Montlake Project Signage Workgroup – Meeting #2

Wednesday, Dec. 13, 2023 | 2-4 p.m.
2345 Eastlake Avenue E., Seattle, WA 98102
Hybrid meeting format

Sign Bridge #1: Technical team review of options – feasibility & regulatory compliance

OPTION 1: (#3) Add additional signing further south on 24th Avenue E (overhead on a signal mast arm) | (#6) Smaller signs mounted on a signal mast arm

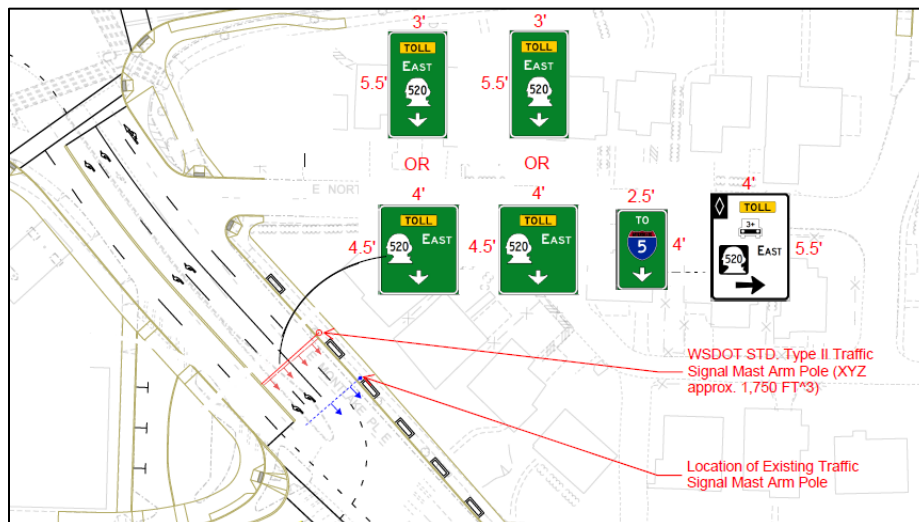
Suryata showed a side-by-side of the original sign bridge plan versus this new Option 1. When the technical team was looking at this location, the first priority was to reduce the size of the signs, and then once the sign size was determined, the team could figure out how to actually support the signs.

The technical team looked at the minimum text size allowed by MUTCD for a location of this nature. For example, the new sign size options are 5.5' x 3' or 4.5' x 4' (versus the original 17' x 9'). The technical team pushed down the text size to six inches for the capital letters and 4.5 inches for the lower-case letters. The technical team recommend the 4.5' x 4' signs which provide more of a balanced look and shorter signs. In trying to maximize the space used on the signs, the team also split the "Eastbound SR 520" sign into two, using two identical signs versus one larger one. Suryata noted there would be two identical signs for this movement because there are two left turn lanes for drivers and the arrows need to be over the lanes (see image below). The new signs would be in a similar location to where sign bridge #1 exists today. It would still be located south of E North Street and Lake Washington Boulevard.

As a result of reducing the size of the signs, additional advance signs at 24th Avenue East would be needed to give drivers a heads up before they get to the East Roanoke Street intersection. For this first option, the advance signs would be placed overhead on a signal mast arm (see image below).

Workgroup member question: Is there a problem with moving the sign bridge further north out of the neighborhood?

Workgroup member question: So, there's no way to move the sign bridge further north because of the underground utilities? Even moving it 10 feet would make a difference so it's not in front of someone's home.

Workgroup member question: Is there an option for the signs to be placed on a cantilever arm and for the cantilever to be installed on the other side (the west side) of Montlake Boulevard?

Workgroup member question: Have you considered putting both the signals and signs on the same signal mast arm?

Workgroup member question: In the spirit of eliminating clutter along Montlake Boulevard, could you mount the advance signs on an existing pole on the east side of the road?

Answer: Yes, because we need people who are turning left onto eastbound SR 520 to see the signs before they approach those turn lanes. The signs with the newly reduced text size would have less legibility distance. As a reminder, MUTCD guidance is 30 feet of legibility distance for every one inch of text height. There are also issues with moving this sign structure elsewhere due to foundation/ground issues and conflicts with underground utilities. Seattle Public Utilities (SPU) has a large water main that runs along Montlake Boulevard. This is what led the contractor to put the original sign bridge where they did.

Answer: We need the signs to be visible enough for drivers approaching the intersection and we need the signs to be south of E North Street. However, the technical team will look into the possibility of moving the sign structure at location #1 further north in the order of 10 feet or so.

Answer: It would be too difficult to have the sign foundation on the opposite side of the street because the arm of the structure would need to span not only the southbound lanes of traffic, but the northbound lanes as well. The signage would be too heavy, so it is not structurally feasible.

Answer: Yes. Putting the signs on the existing signal mast arms with the traffic signals poses spacing issues. Even though we have scaled down the size of the signs, trying to fit the four signs and the three traffic lights all onto a single mast arm is too much. Additionally, the arrows – which must be centered over the lanes – would compete with the signal's placement. And the location of the signals is not where the signs need to be along the roadway. Last, there are also weight concerns with having all that infrastructure on one mast arm.

Answer: There aren't a lot of poles along this section of roadway. There is one existing pole, but it isn't in the correct location for the advance signs. However, we'll go back and check if there is an opportunity for this suggestion for our next workgroup meeting.

OPTION 2: (#3) Add additional signing further south on 24th Avenue E (side mounted signs on the side of the road) | (#6) Smaller signs mounted on a signal mast arm

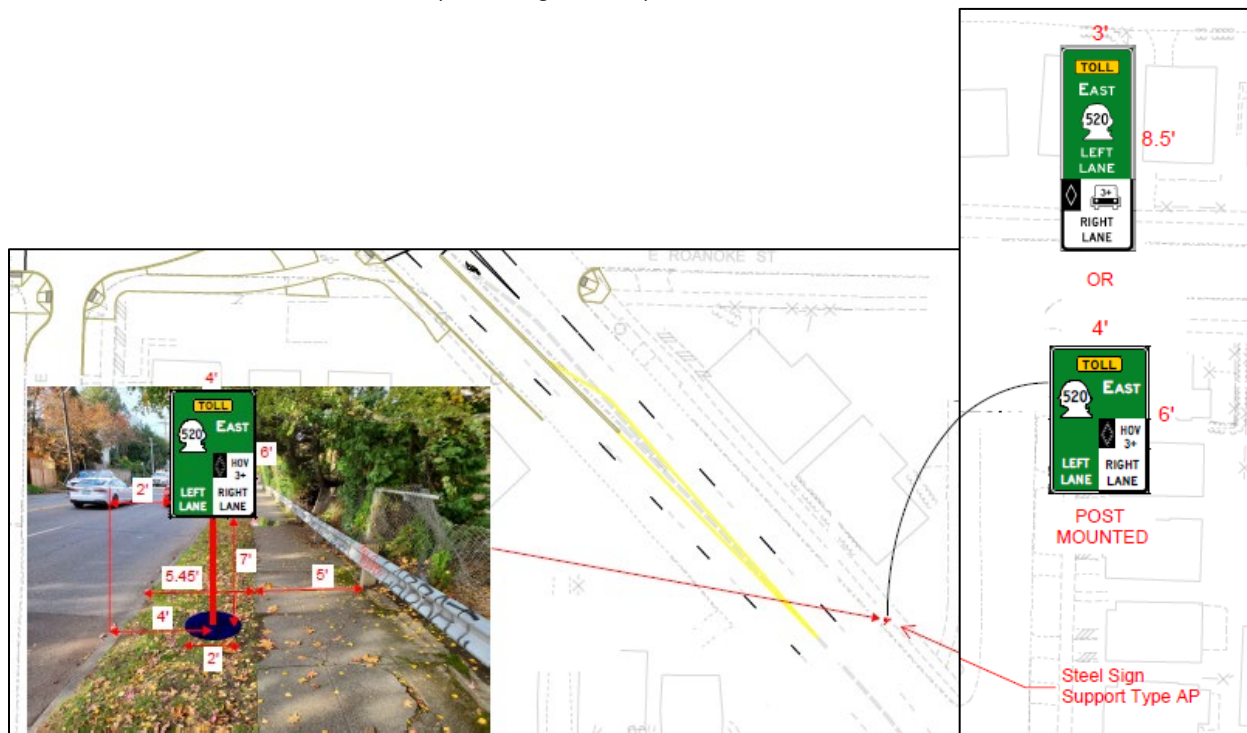
Suryata described Option 2 for sign location #1. Option 2 is the same as Option 1 in that it includes the main signs at East Roanoke Street on a new signal mast arm. However, the advance signs at 24th Avenue East would be mounted on a pole on the side of the road (in the planting strip) instead of overhead on a mast arm. This advance signage would take drivers a little bit longer to process because the signs are combined, instead of over the lanes (see image below).

Workgroup member comment: The advance signing that is mounted on a pole and "stacks" the arrow directions vertically is logically inconsistent.

Workgroup member comment: I feel like a 6-foot sign on a post may be larger than it seems in the picture here. I think it's more important that neighbors walking on the sidewalk in this area are comfortable and don't have to look at giant signs next to the sidewalk.

Workgroup member question: I'm wondering if it's better to have three poles to have even smaller signs? Having a huge 6-foot sign on the sidewalk seems huge.
